Wollongong Local Planning Panel Assessment Report | 19-June -2019

| DA No. | DA-2018/1545 |
| Proposal | Residential - demolition of existing structures, tree removal, construction of dual occupancy and Subdivision - Torrens title - two (2) lots |
| Property | 30 Hewitts Avenue, THIRROUL NSW 2515 |

DESCRIPTION
General Site Plan
PAGE SCALE
1 : 250
PAGE SIZE
A3
G-100

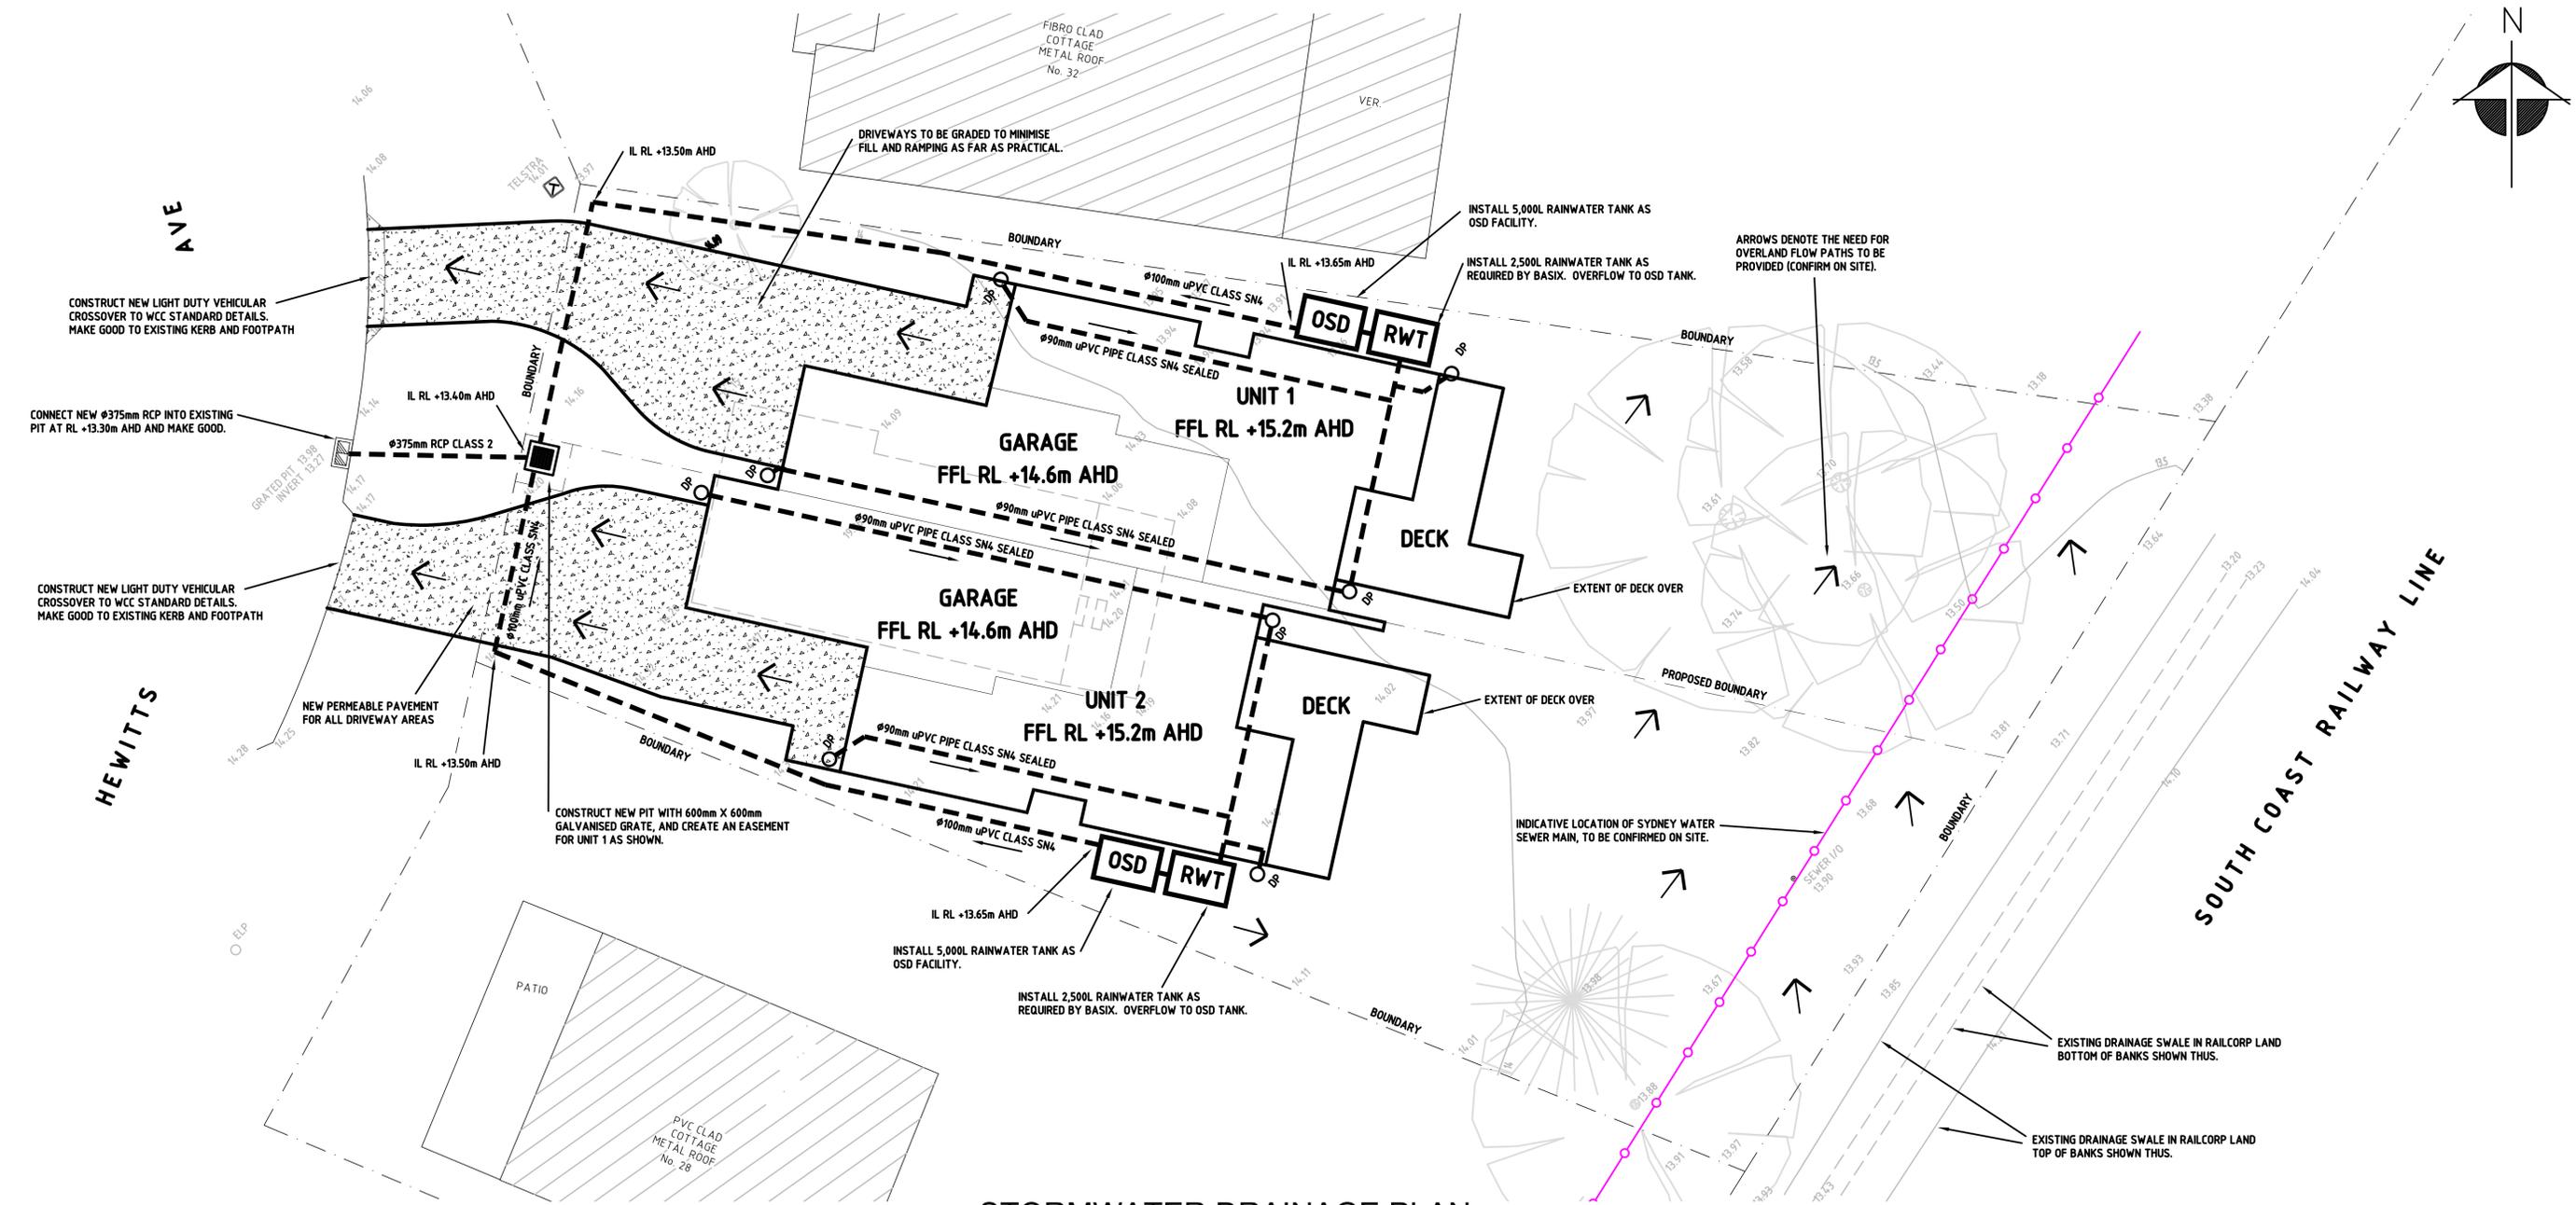
- 7 **Tree Retention/Removal**
This consent permits the removal of trees numbered 1 to 8 as indicated on Drawing: G-099-1 dated 17 April 2019 prepared by Progenia. No other trees shall be removed without prior written approval of Council.

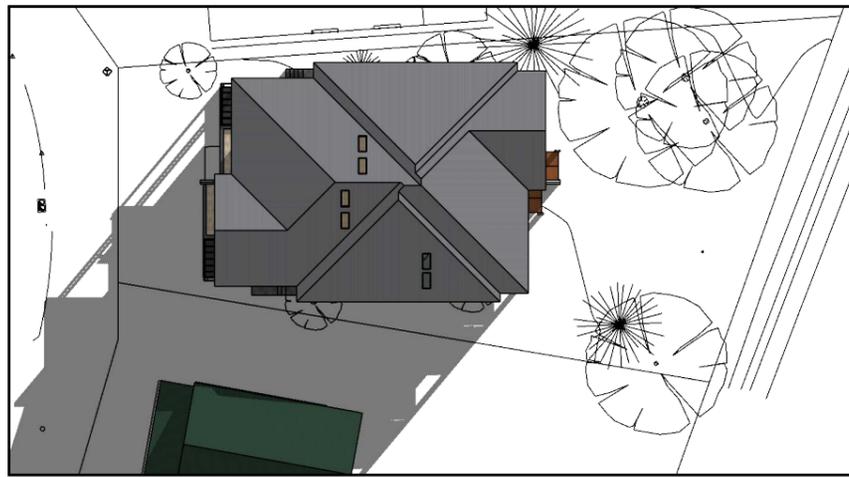
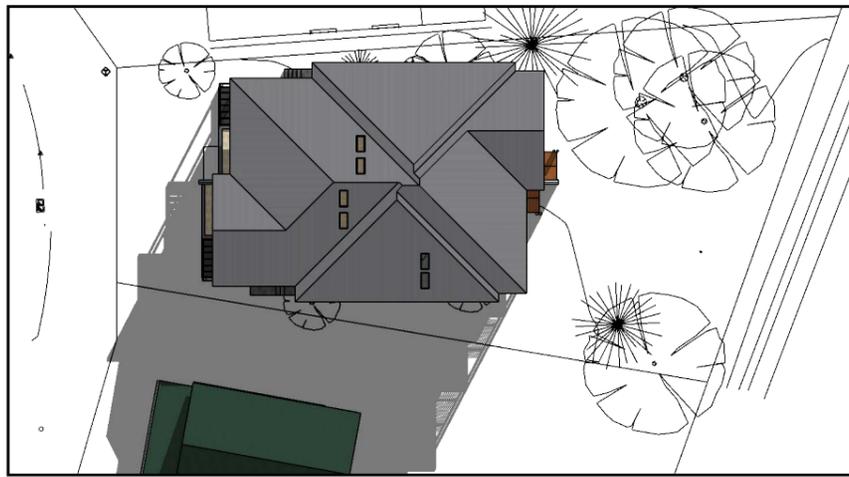
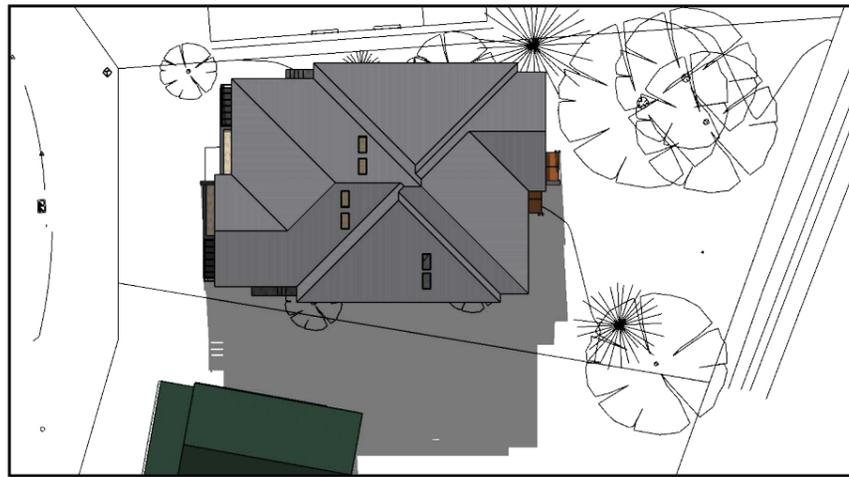
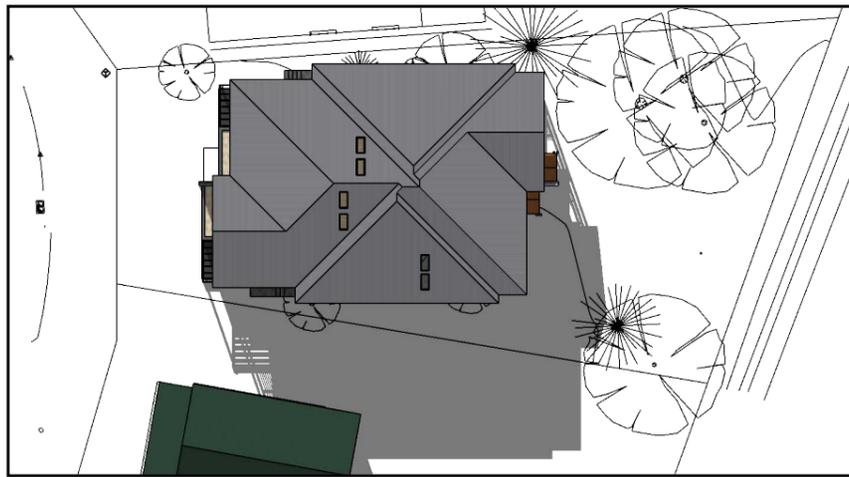
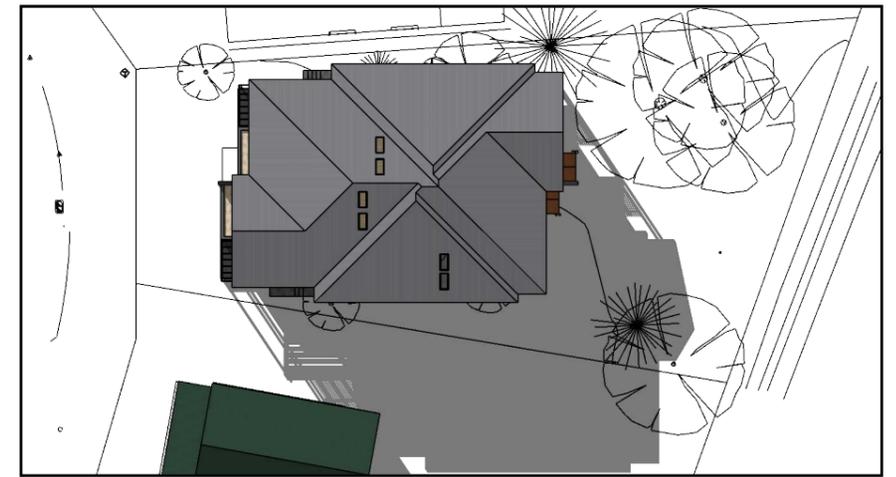
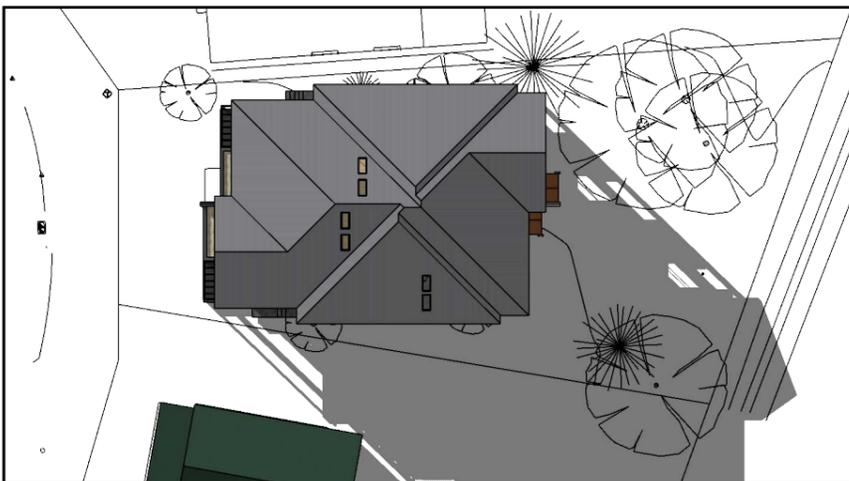
| Concern | Comment |
|--|--|
| <p>1.Overshadowing: The objector has concerns regarding the potential loss of sunlight to the living areas and garden along the northern side of their property.</p> | <p>Submitted shadow diagrams detail limited over shadowing to the north–western corner of the partially enclosed front verandah and the driveway of adjoining dwelling between 9.00am to 11am mid-winter.</p> <p>As such the proposal meets the requirements for solar access within the WDCP.</p> <p>The development proposes 1.26m side setback (which is more than the minimum required 0.9m) and compliant height provisions.</p> <p>In general overshadowing from developments within similarly oriented (east–west oriented) sites have a domino effect and is not completely avoidable in such cases. Any overshadow impact from a fully compliant 2 storey single dwelling at the exact location would be no different to the impact from one of the units of this dual occupancy composition.</p> <p>Amendments made to the plans are considered to significantly minimise any over shadowing to the southern property.</p> |

| Drawing Name: LANDSCAPE PLAN | Job No. DML 18/010 | Dwg.No | |

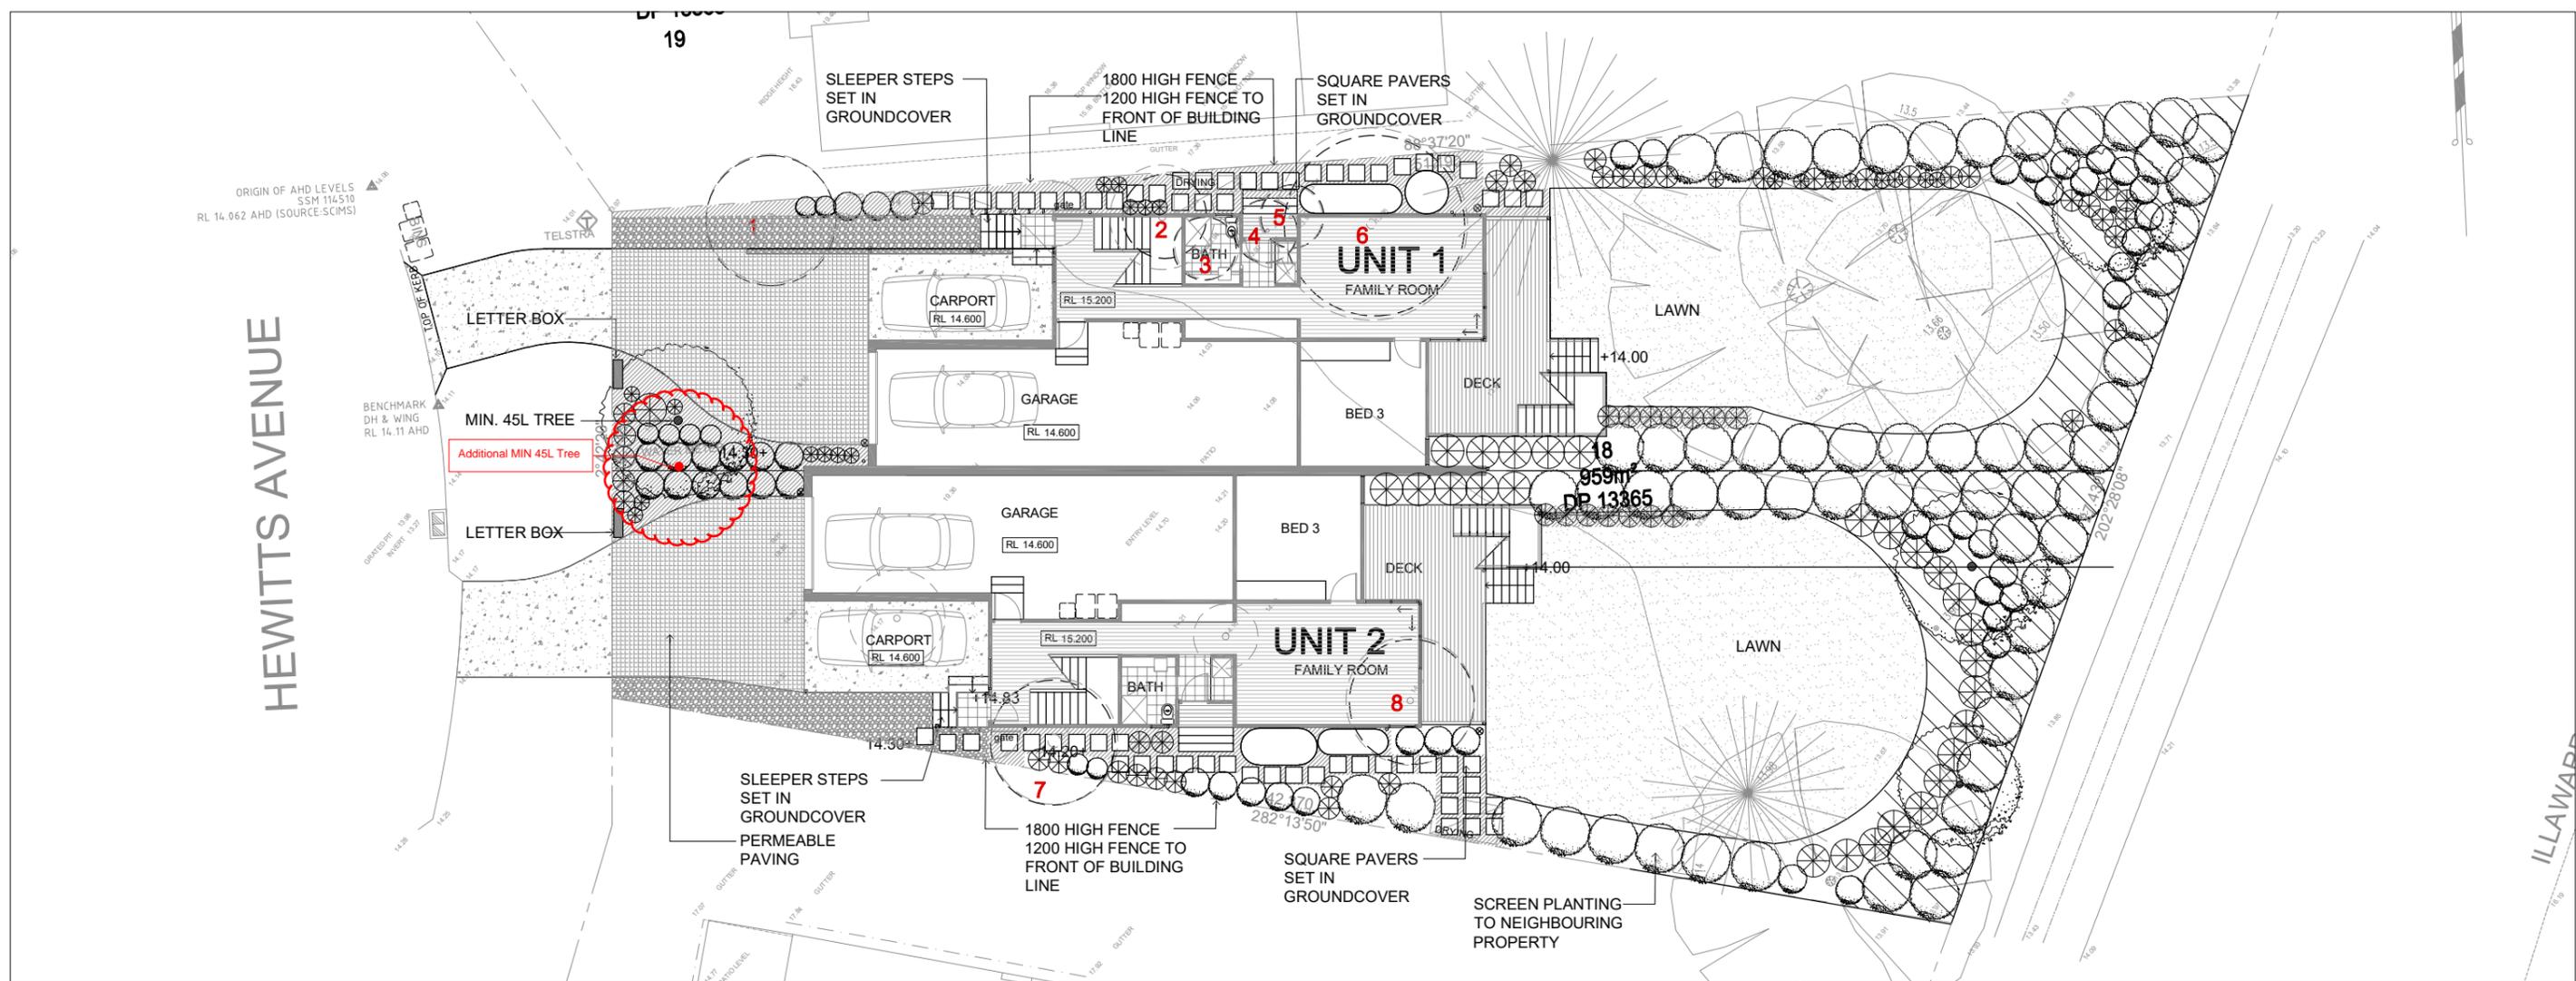
| Concern | Comment |
|---|---|
| 10. Lack of details of landscape plants | <p>Applicant has submitted a landscape concept plan. Conditions are also included for a landscape plan to be submitted to the certifier that complies with the DCP requirements for landscaping.</p> |

19 The submission of a final Landscape Plan to the Principal Certifying Authority, prior to the release of the Construction Certificate. The final Landscape Plan shall address the following requirements:
